Application for Works Approval

Works Approval Number W6338/2019/1

Applicant BHP Billiton Iron Ore Pty Ltd

Premises Mining Area C
Mining Tenement ML281SA and ML249SA
NEWMAN WA 6753

Figure 1: Infrastructure and monitoring locations

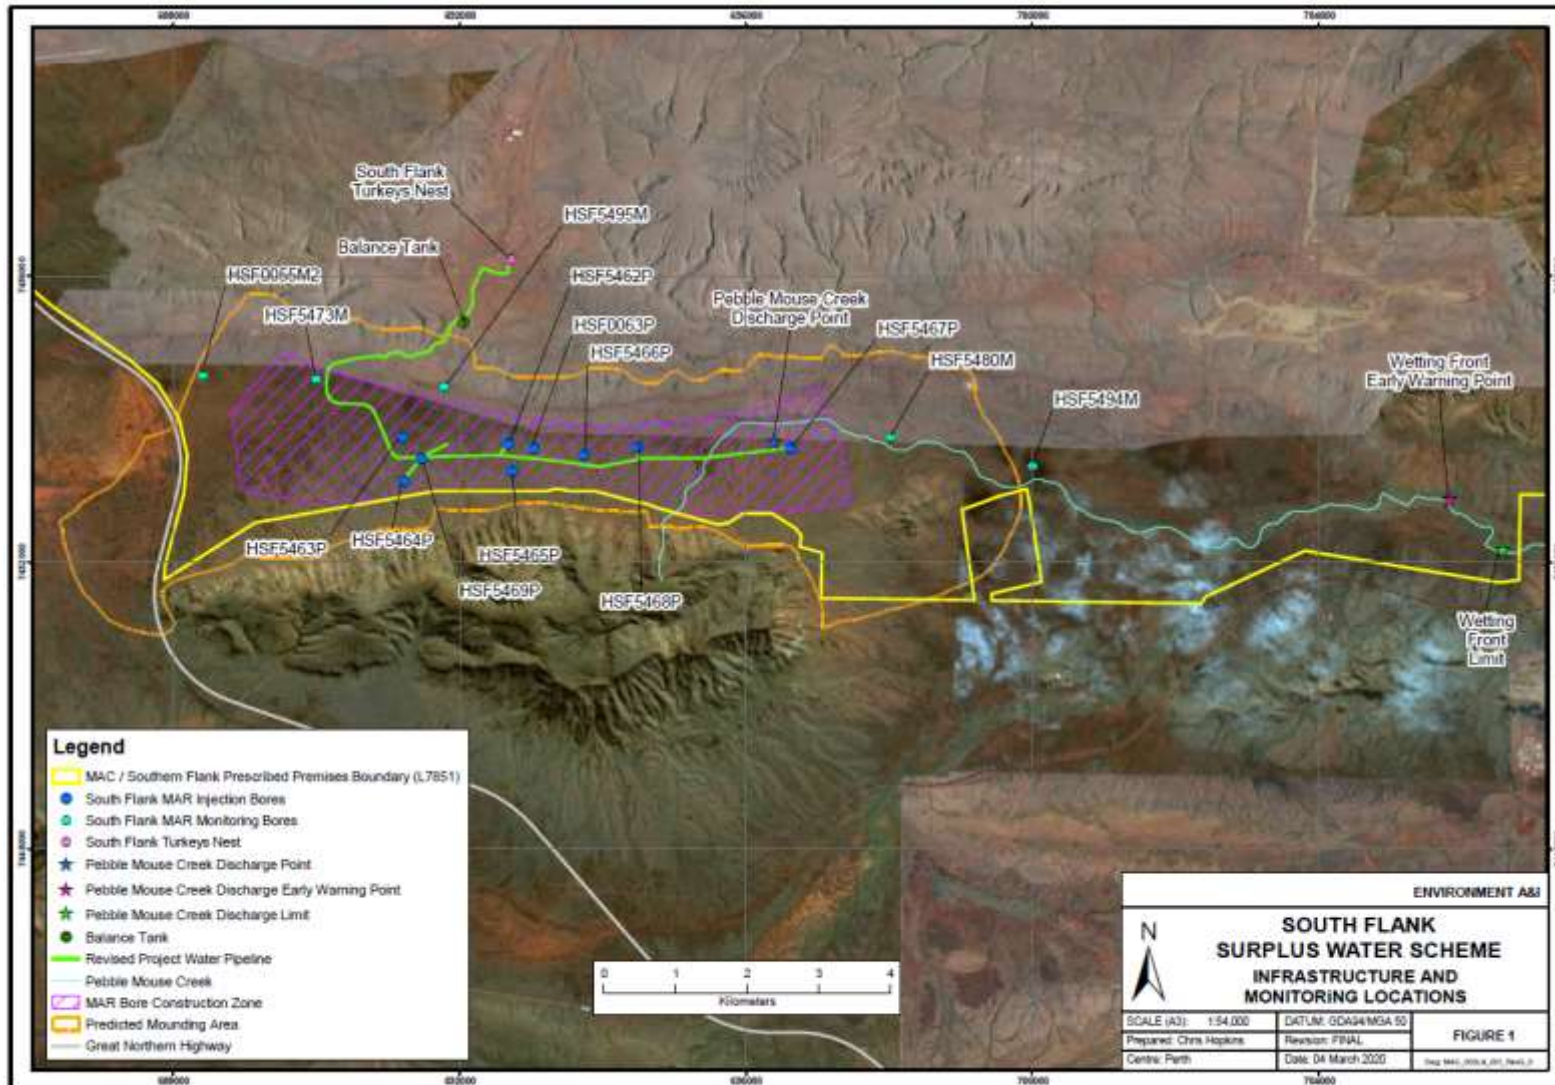
Condition	Summary of Applicant comment	DWER response
Table 1, Item 2	Remove the reference to the flow meter. This is captured in Line Item 1.	Updated in works approval and Decision Report.
Table 1, Item 4	Amend the pipe diameter to 500mm	Updated in works approval and Decision Report.
Table 1, Item 4	Amend the wording on rip rap protection to "Rip rap protection underneath, to each side and downstream of the discharge pipe".	Updated in works approval and Decision Report.
Table 1, Item 4	Add "Flow meter to calculate the flow".	Updated in works approval and Decision Report.
Table 2, Item 1	Replace reinjection bore HSF0067P with HSF5467P (as per Figure 1). This appears to have been a typo in the bore name.	Updated in works approval and Decision Report.
Table 2, Item 3	Add Monitoring bore HSF5495M (currently on Figure 1). This was the new monitoring bore that relates to Ministerial Statement 1072 and is already shown on Figure 1 of the works approval.	Updated in works approval and Decision Report.
